**Hardin Park
High School Baseball – Softball Field**

Assessment October 23, 2018

ADA Checklist for Existing Facilities

Building: High School Baseball/Softball Fields
And Noon Rotary Club Field

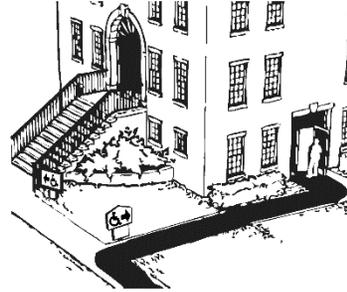
1.38 If the main entrance is not accessible, is there an alternative accessible entrance?

No

- Designate an entrance and make it accessible
- Refer to 1.13

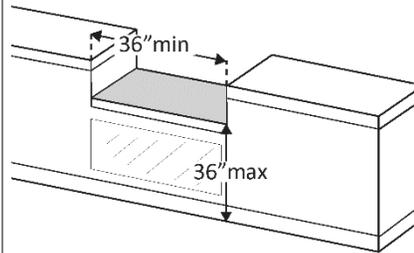
2.76 Is there a portion of at least one of each type of counter that is:

No higher than 36 inches above the floor?

At least 36 inches long?
[904.4.1]

No
Measurement:

- Lower section of counter
